HUNTSVILLE UTILITIES SOUTHEAST WATER TREATMENT PLANT

To: All Plan Holders

From: Tetra Tech

Date: December 10, 2014

HUNTSVILLE UTILITIES
SOUTHEAST WATER TREATMENT PLANT
**SLUDGE FILTRATE
PUMP STATION
PLAN & SECTION**

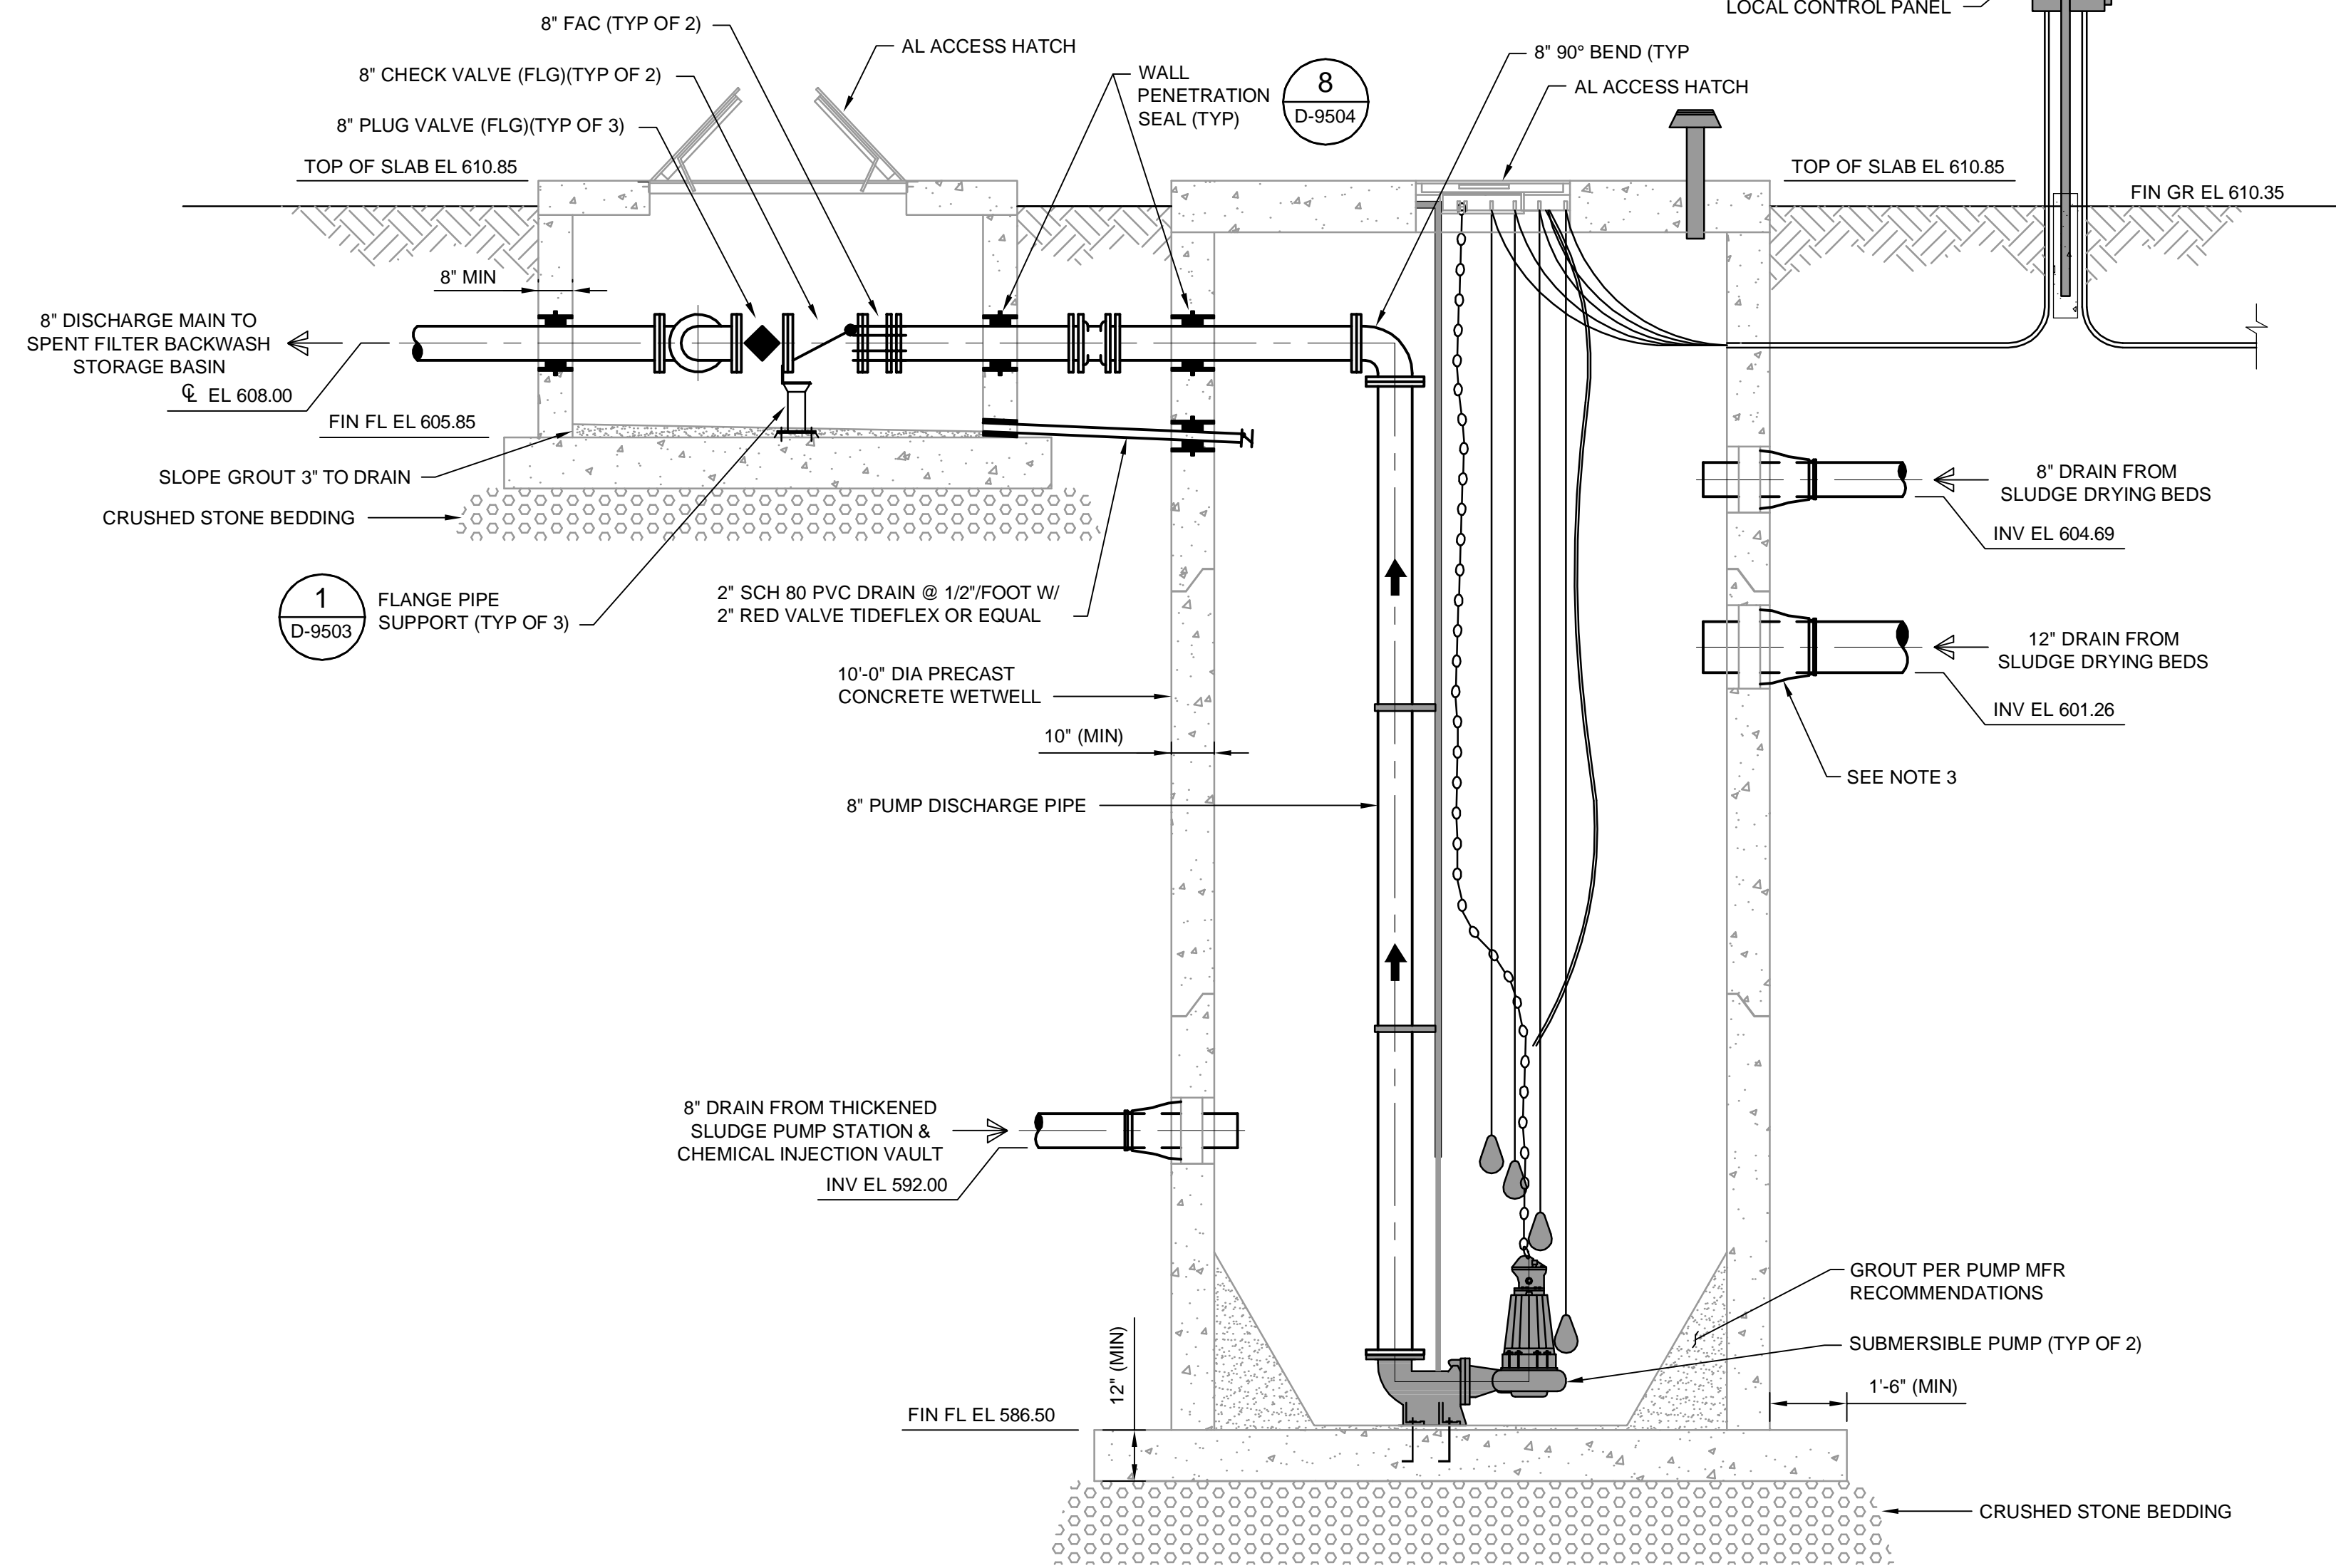
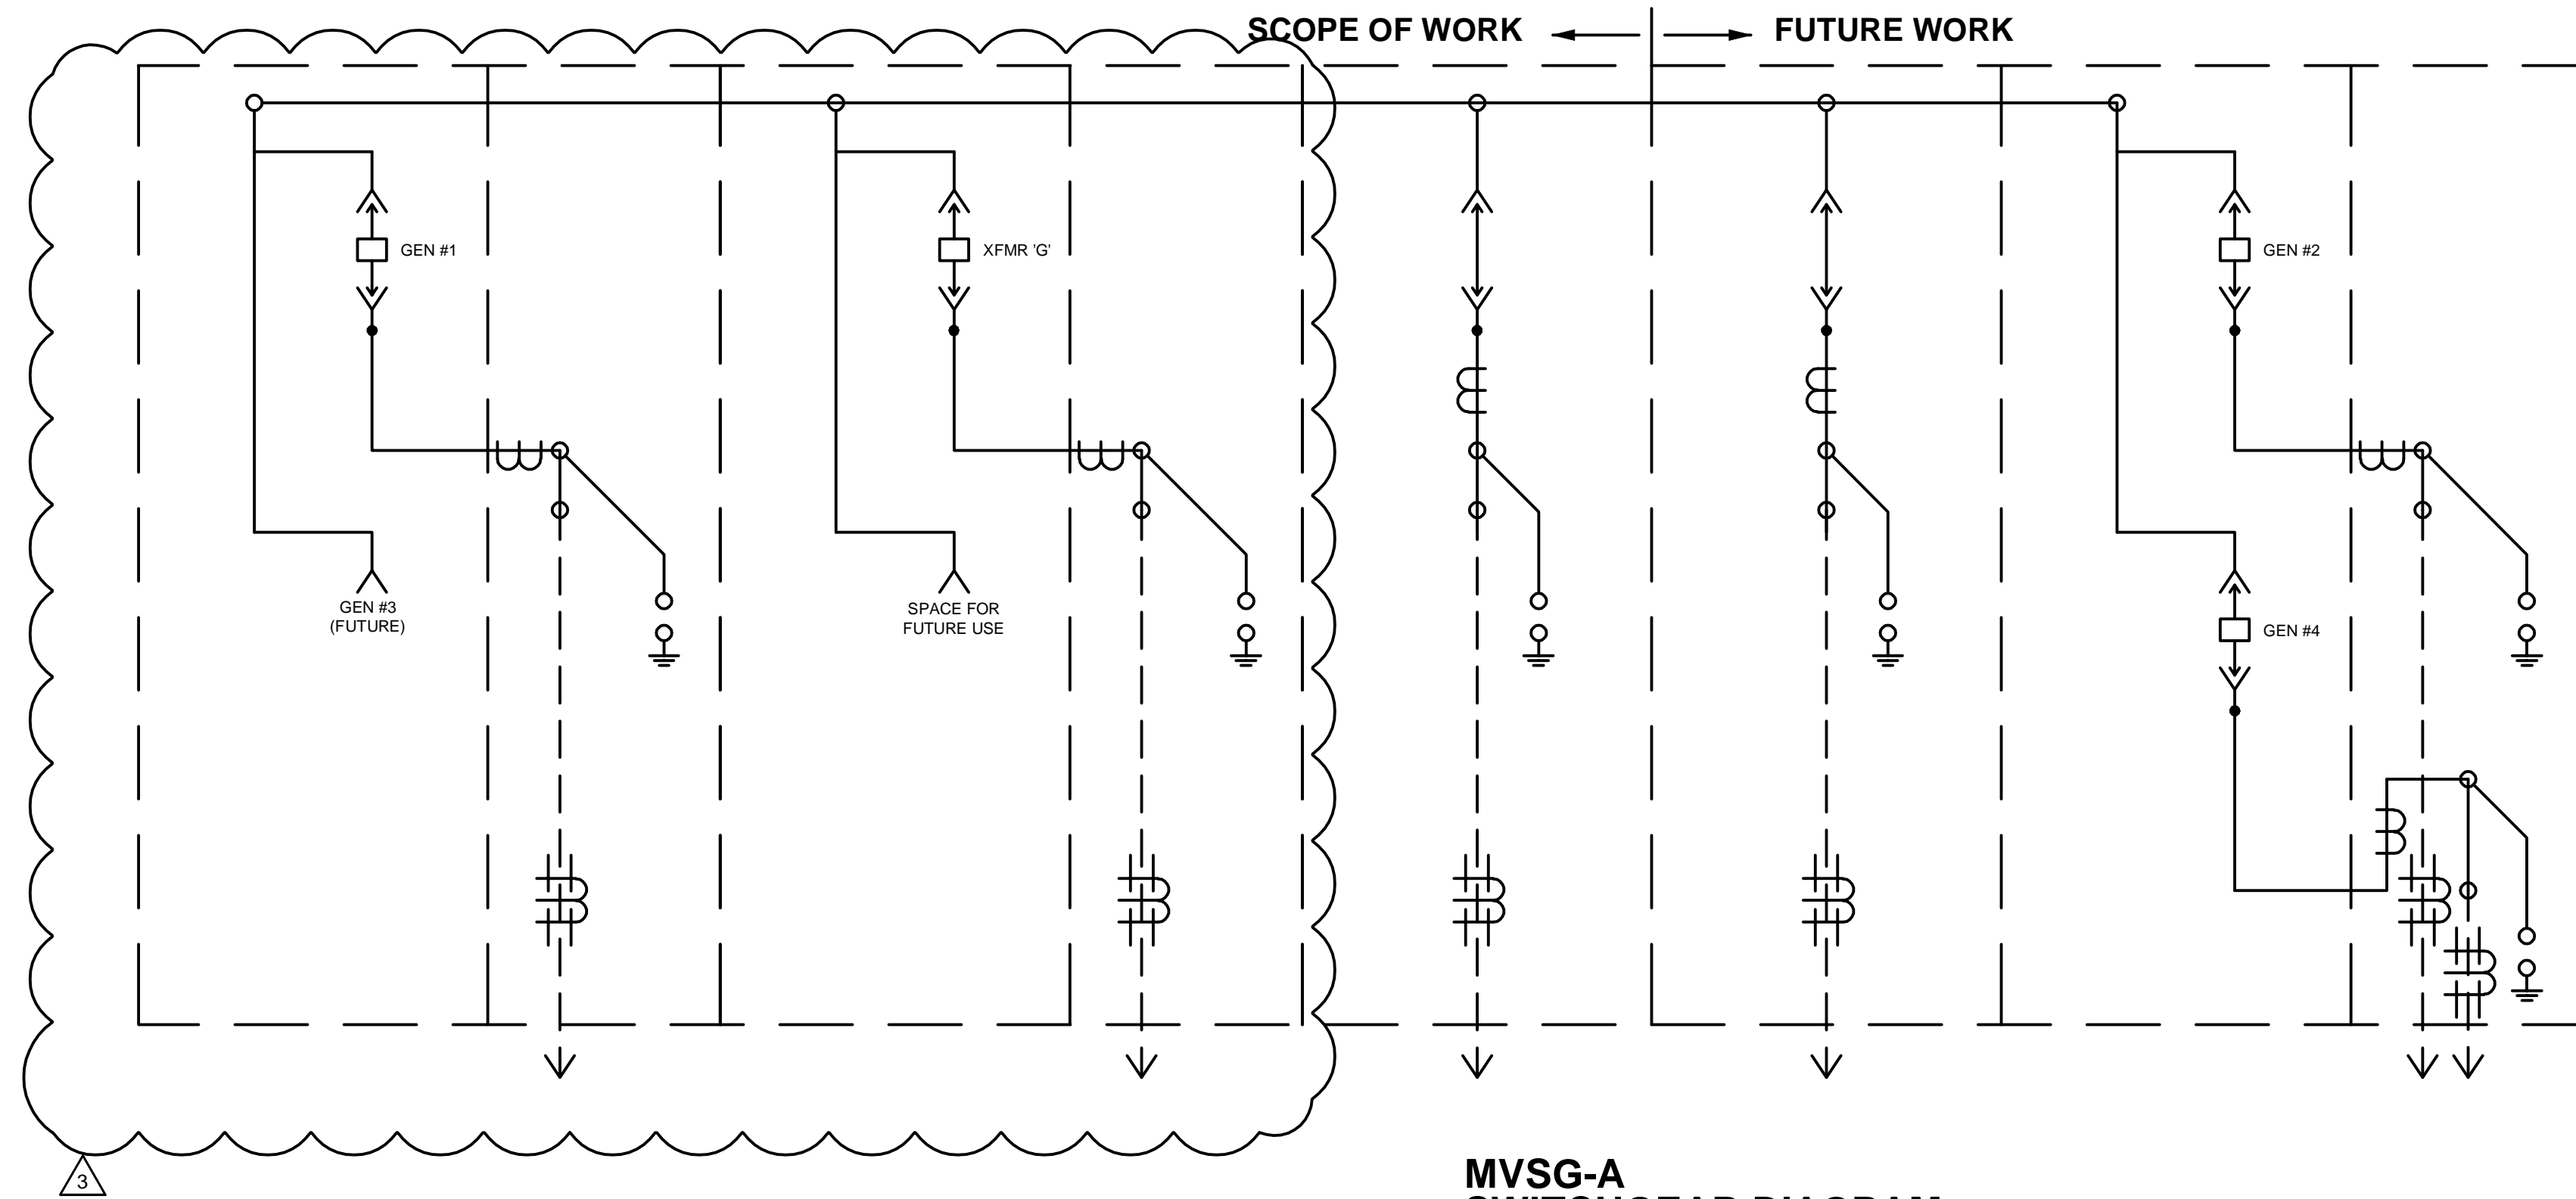
- Item No. 23: **Sheets D-0101, D-0104, D-0601 and D-6103.** Replace these sheets with revised sheets (attached) which clarify the water supply piping to the filtrate pump station.

**MVSG-A
SWITCHGEAR DIAGRAM**

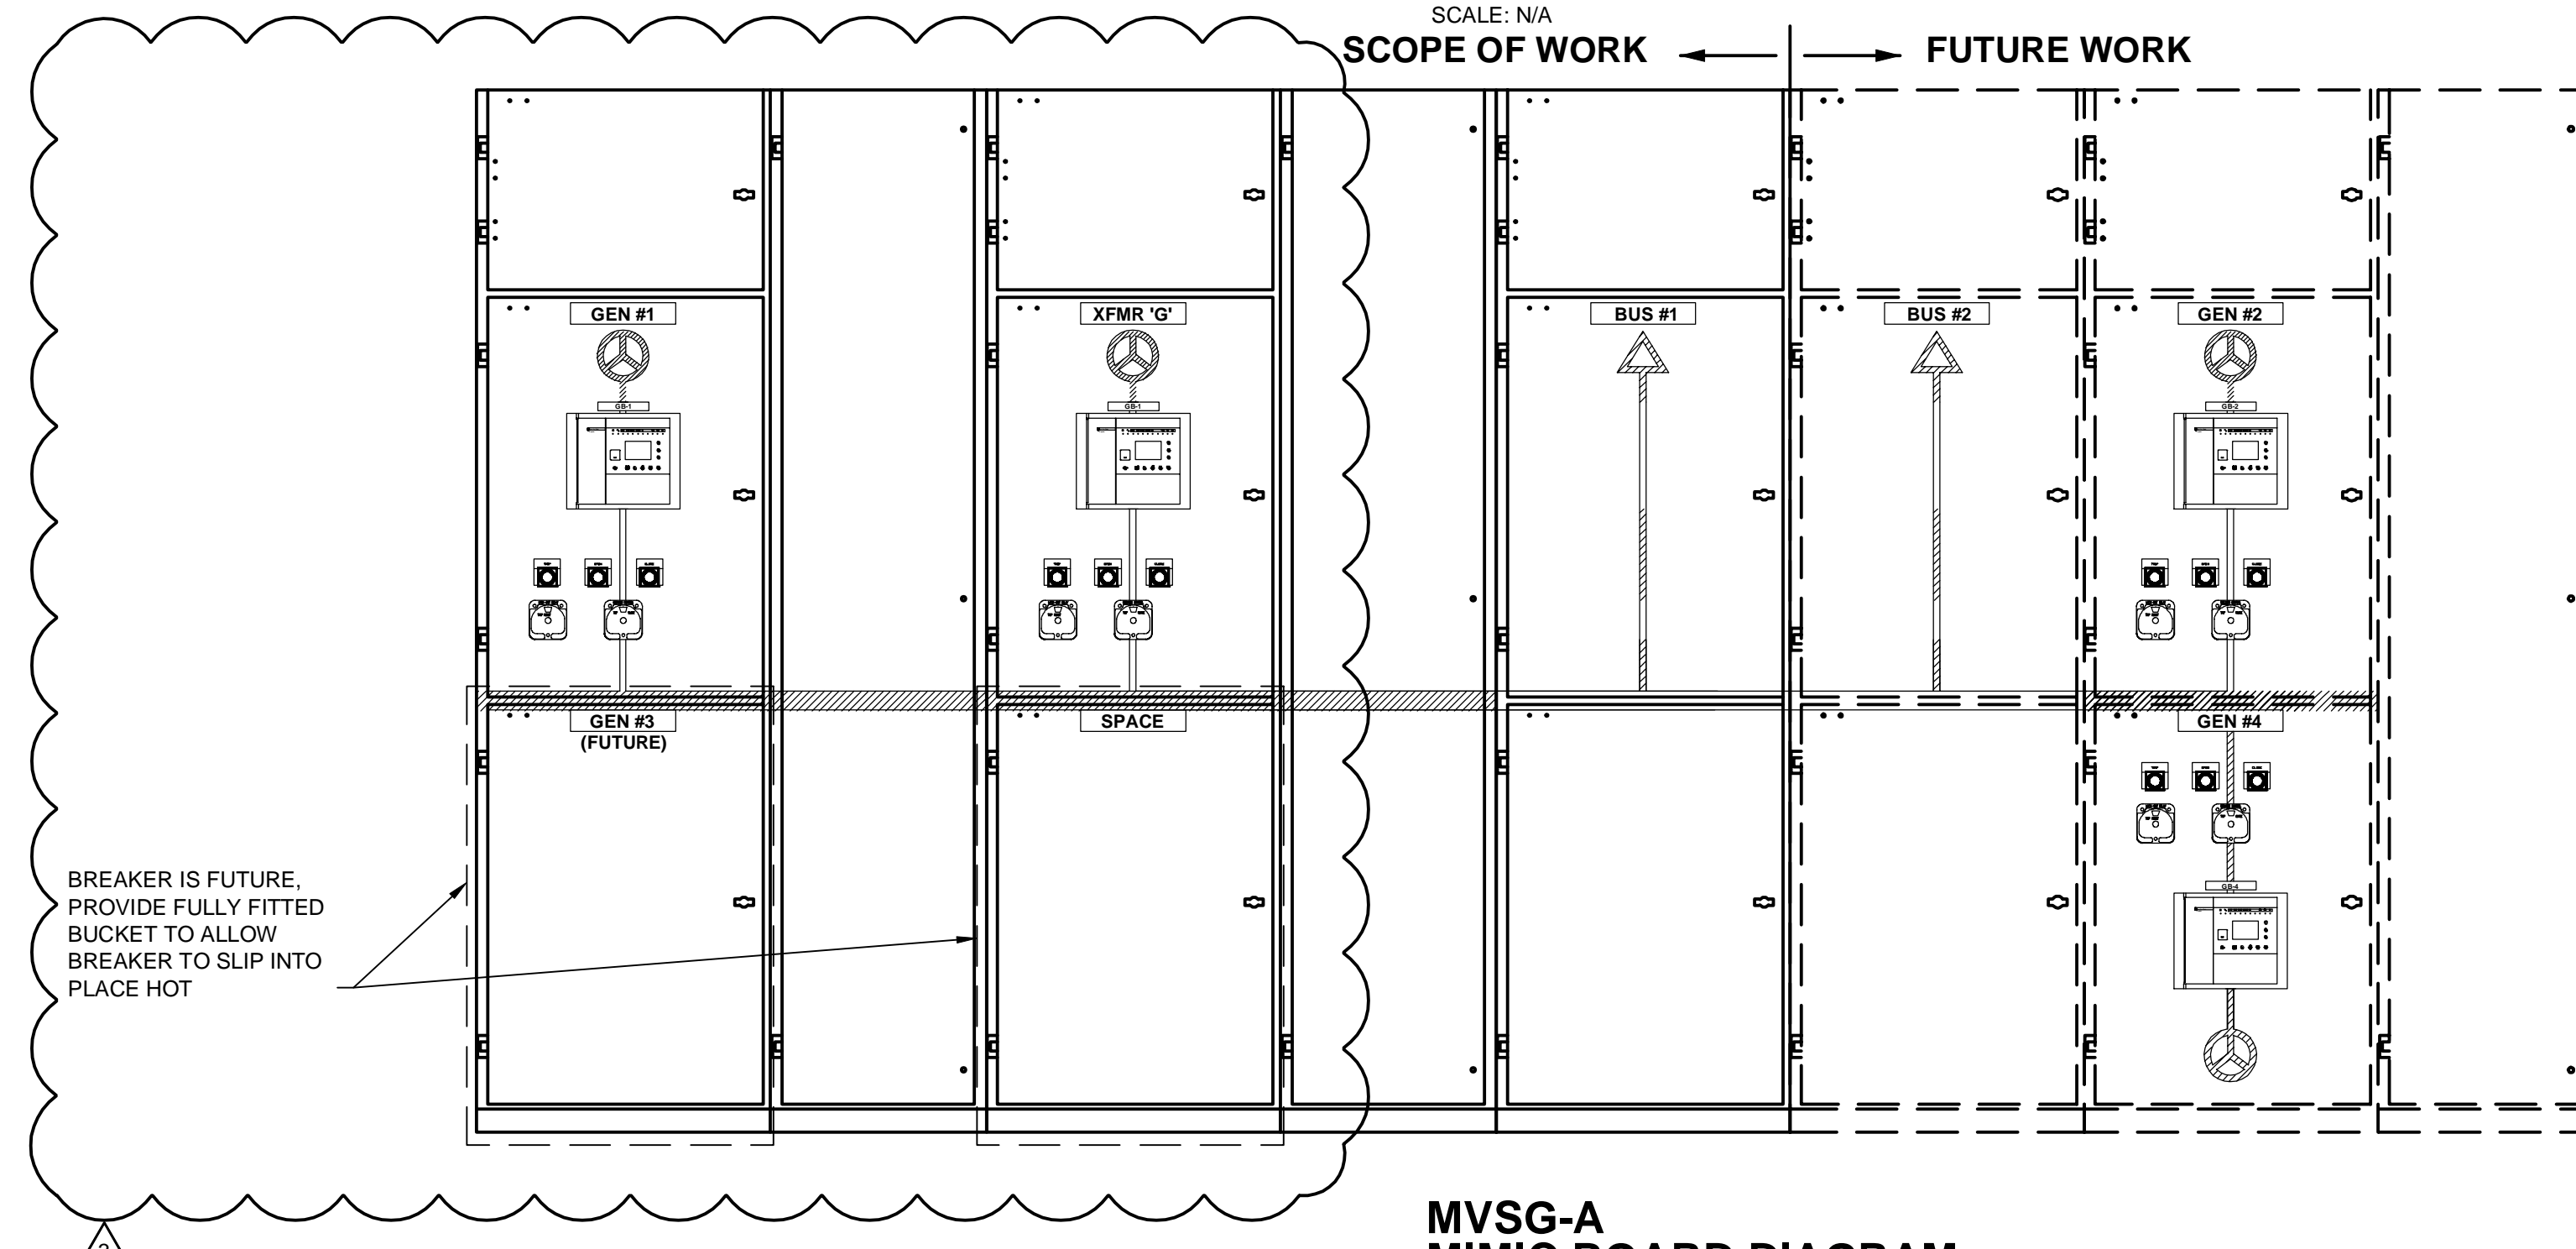
- Item No. 39: **Sheet E-8302.** Replace the existing sheet with a modified sheet (attached) noting the additional circuit breaker.
- Item No. 40: **Sheet E-8401.** A switchgear interface station is shown adjacent to the west door for the electrical room and a Prospective Subcontractor is requesting direction with regard to this item. Bidders are advised that this component is shown on Sheet E-0803 and it is further described in Section 26 09 13.
